REQUEST FOR TENDER No. 25-021

Shorewood Dr Watermain Looping – San Pareil Water Service Area

Addendum 1

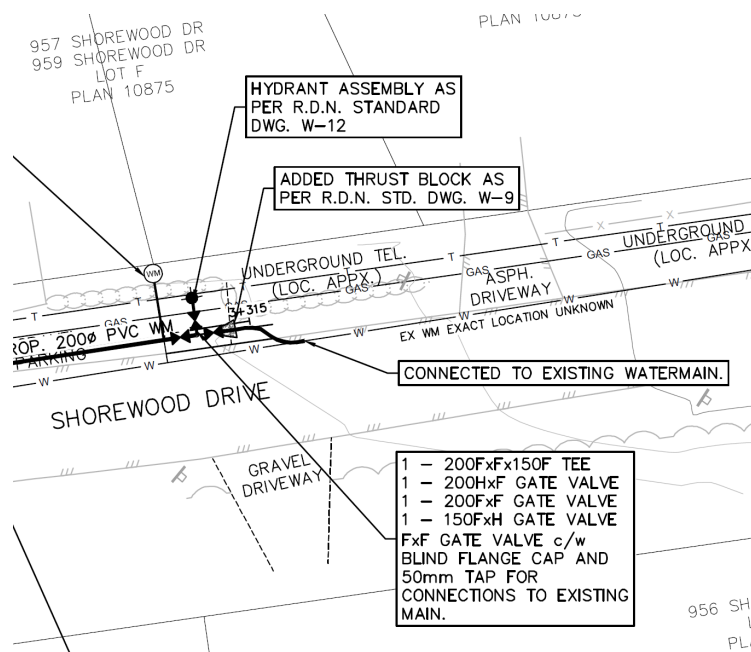
Question 1: What are the connections at the existing Tee's? flanges or hub with a stubbed pipe.

Answer 1: On Shorewood Dr, the existing Tee is 200F x 200F x 150F Tee. The gate valve on the east side of this Tee is 200FxF with blind flange cap, tapped to connect the existing 38mm/50mm main. Please see the detail below -
